Common Mode RL for 40GBase-CR4/SR4 and 100GBase-CR10/SR10

- **Proposal: Modify the common mode return loss spec for clauses 85, 86.**
- **Why: To support backwards compatibility of future 100G CR4 and SR4 variants and accommodate CR10/SR10 connectors**

Original ba contribution Jan 09

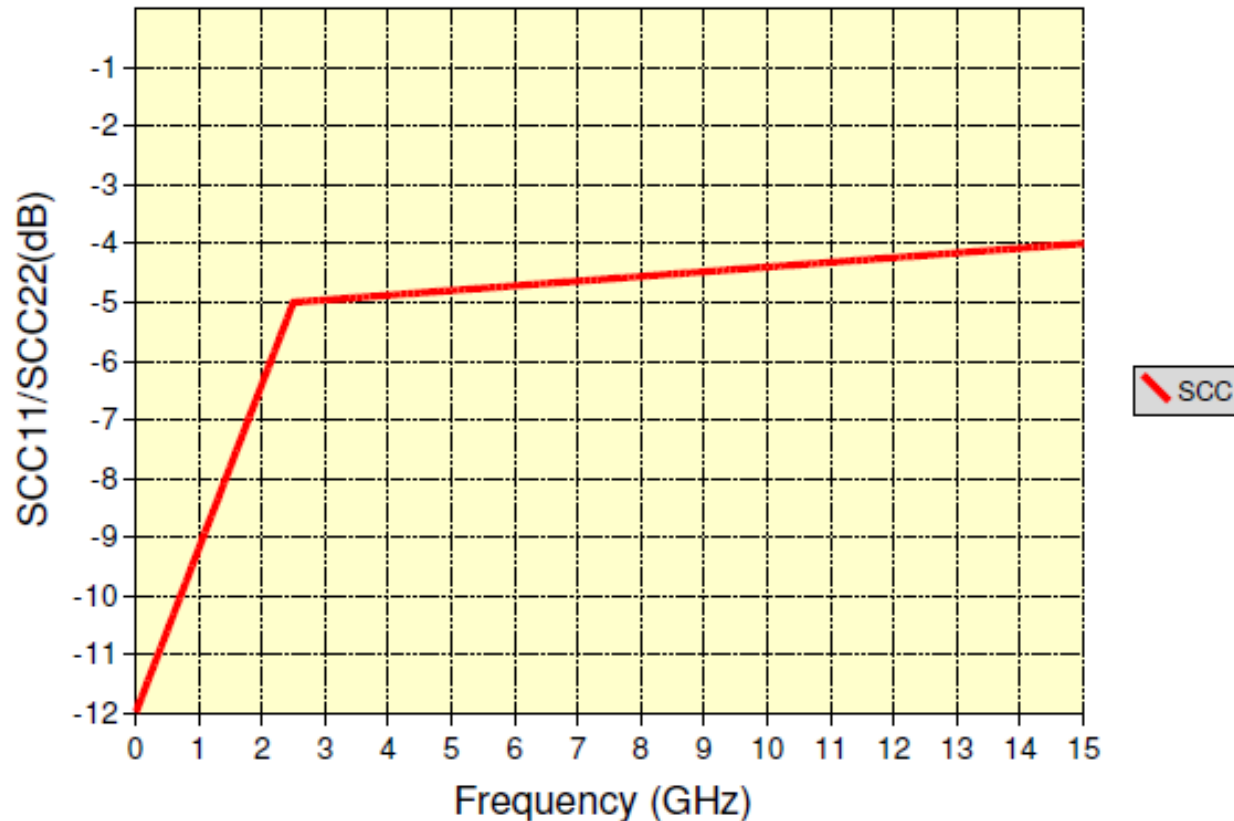
Proposed Change: Common Mode RL Limit

- Replace current common mode RL limit with -3dB (flat)

CM return loss of CR10/SR10 MCB-HCB

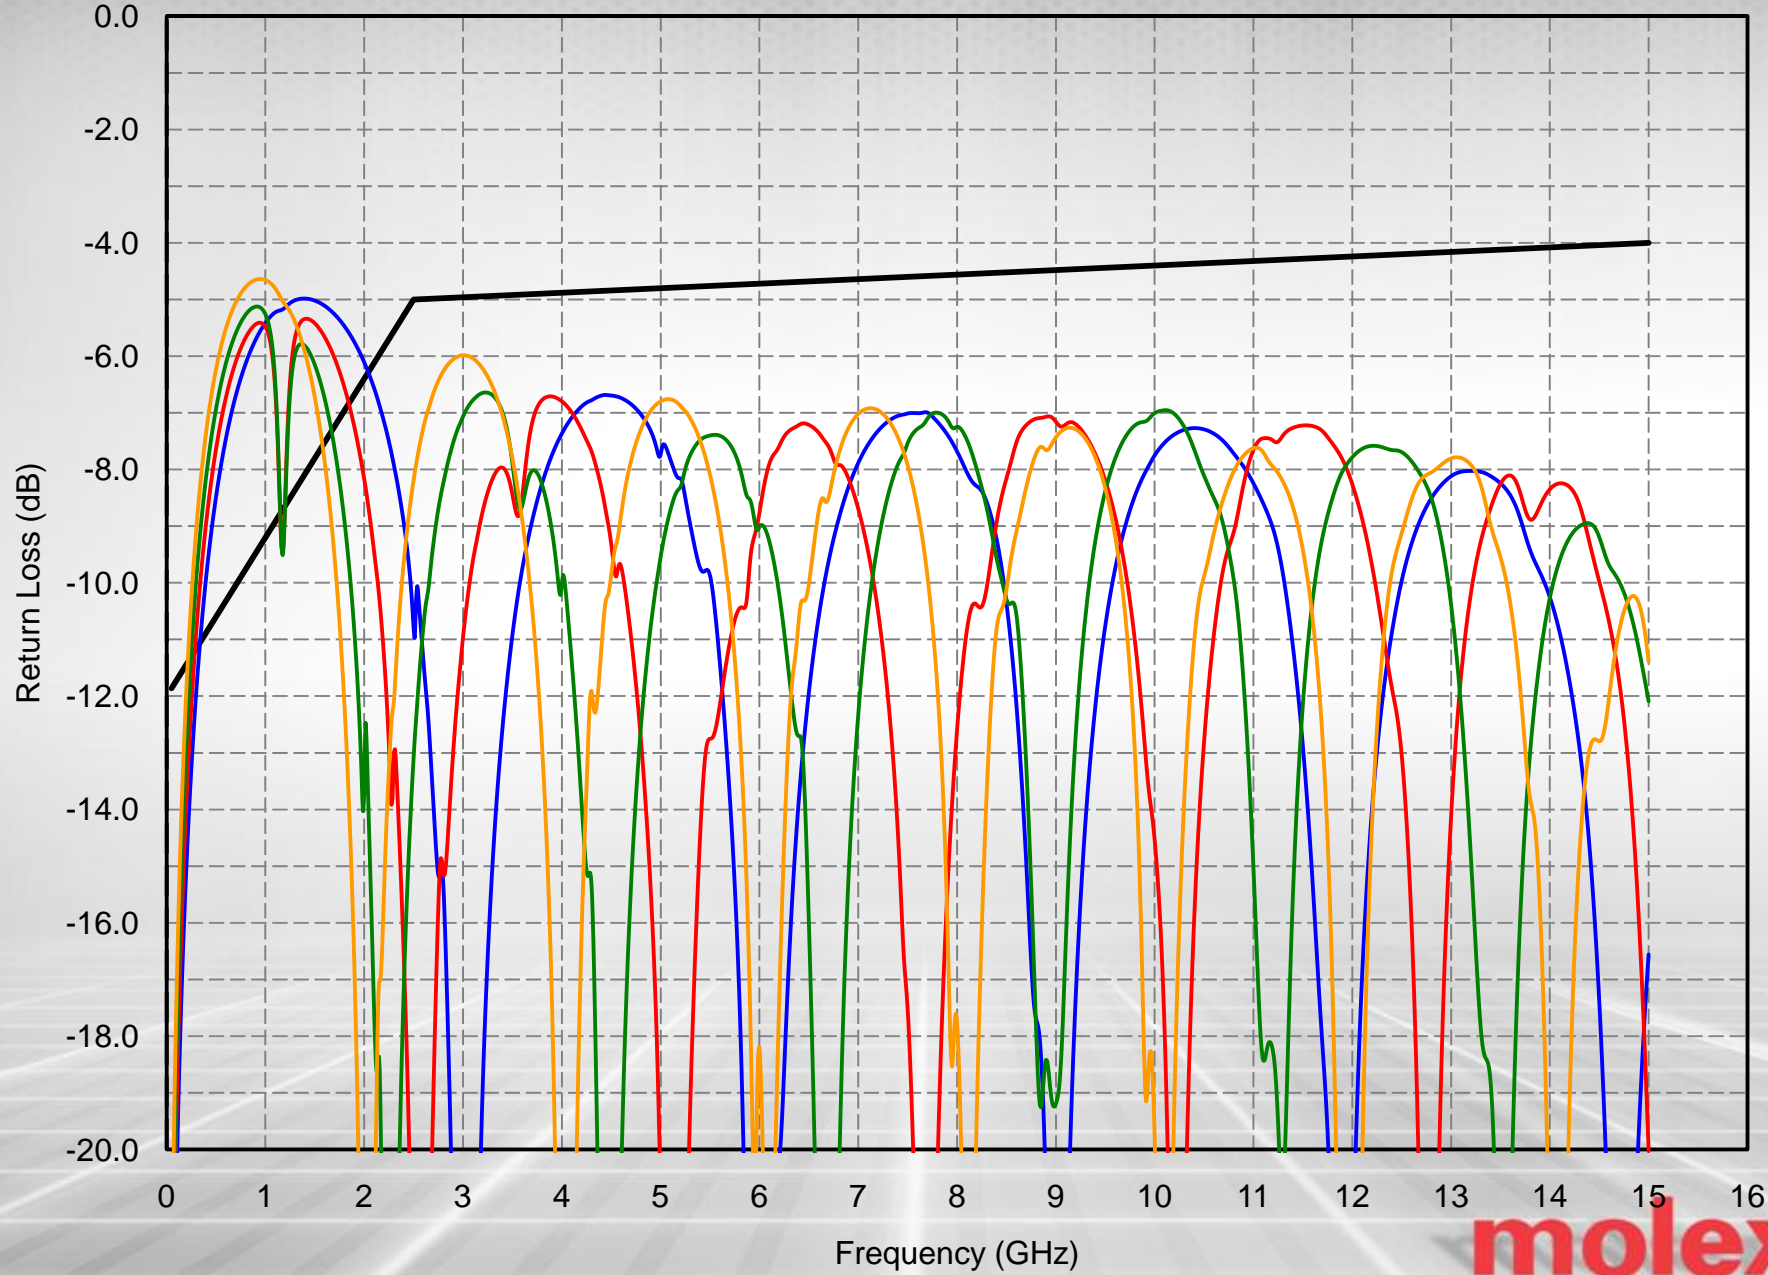
- › **Change the common mode RL specification for SR4/10, CR4/10 to 3dB based on:**
 - CR10 connector performance measurements
 - New QSFP25+ connector performance measurements
 - Common mode power spectrum
 - Lack of Common mode return loss impact on EMI
